THE CITY OF NEW YORK
OFFICE OF THE MAYOR
NEW YORK, N. Y. 10007

Technical Memorandum for the Coney Island Rezoning FEIS
CEQR Number 08DME007K TM002
July 22, 2009

Roadway Network with Modified Wonder Wheel Way
Figure 3

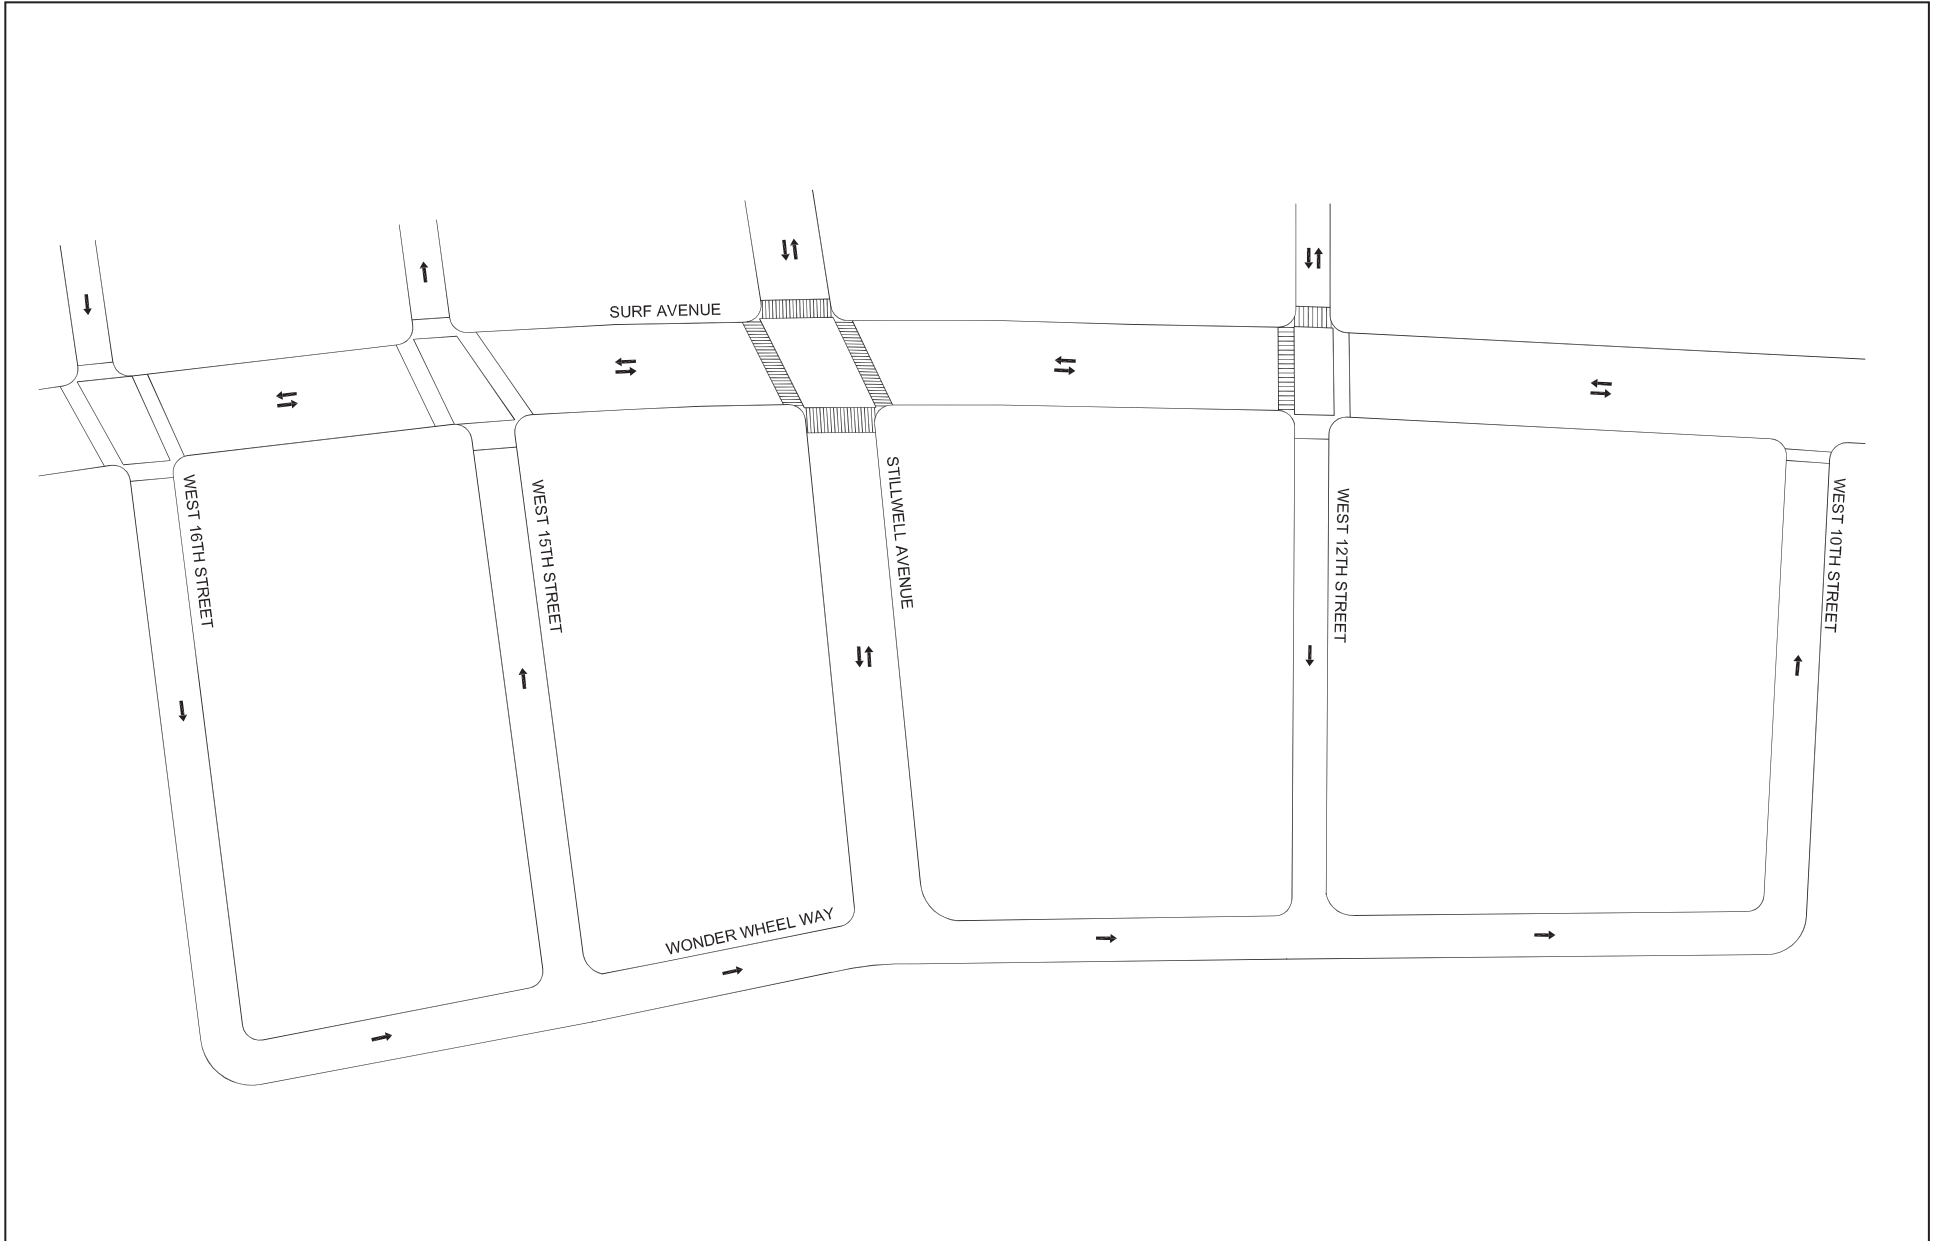
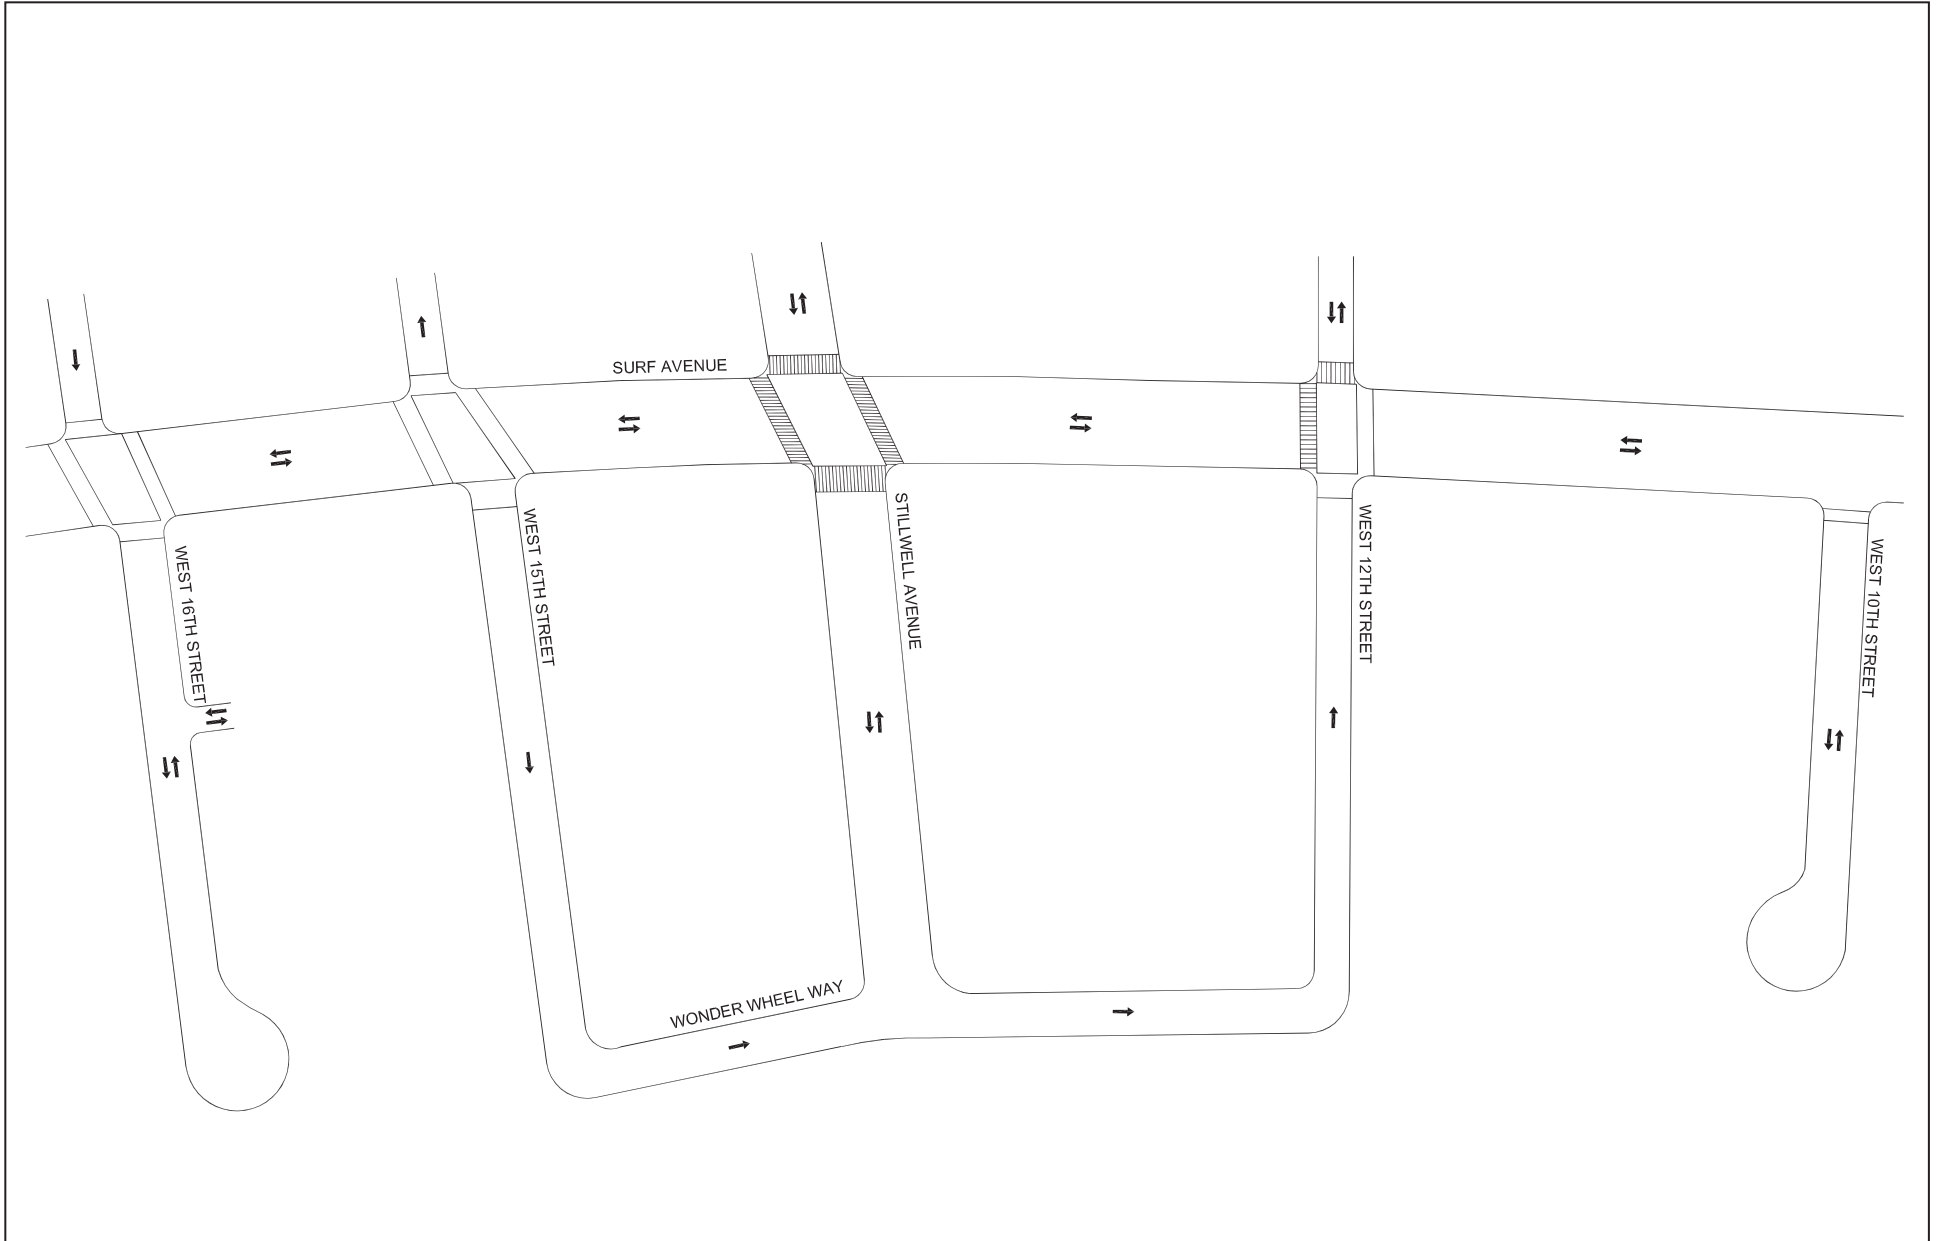
Traffic directionality due to the modification of the proposed Wonder Wheel Way between West 15th and West 16th Streets and West 12th and West 10th Streets would be different from that assumed in the FEIS. In the FEIS, West 16th Street was assumed to operate as one-way

southbound with two travel lanes, West 15th Street was assumed to operate as one-way northbound with two travel lanes, West 12th Street was assumed operate as one-way southbound with one travel lane, and West 10th Street was assumed to operate as one-way northbound with two travel lanes. As a result of the modification to the proposed Wonder Wheel Way, West 16th Street would operate as a two-way roadway with one lane in each direction, West 15th Street would operate as one-way southbound with two travel lanes, West 12th Street would operate as one-way northbound with one travel lane, and West 10th Street would operate as a two-way roadway with one lane in each direction. Stillwell Avenue would continue to operate as two-way with one travel lane in each direction, and Wonder Wheel Way would continue to operate as one-way eastbound with two travel lanes. The roadway networks analyzed in the FEIS and in this Technical Memorandum are shown in Figures 2 and 3, respectively.

Vehicular trips were reassigned throughout the roadway network due to the modification to the proposed Wonder Wheel Way. Wonder Wheel Way would not extend westward to West 16th Street, and vehicles exiting the parking garage were reassigned to exit from West 16th Street onto Surf Avenue as opposed to using Wonder Wheel Way and exiting via West 15th Street or Stillwell Avenue. Taxi pick-ups and drop-offs would circulate through the site via Wonder Wheel Way, similar to the FEIS, with reassignments based on altered access/egress roadways. Due to the modification, taxi trips would enter the roadway network along West 15th Street (as opposed to West 16th Street as analyzed in the FEIS) and exit through West 12th Street (as opposed to West 10th Street as analyzed in the FEIS). Delivery truck routes would be similar to those of taxi trips; trucks could load/unload along Wonder Wheel Way.
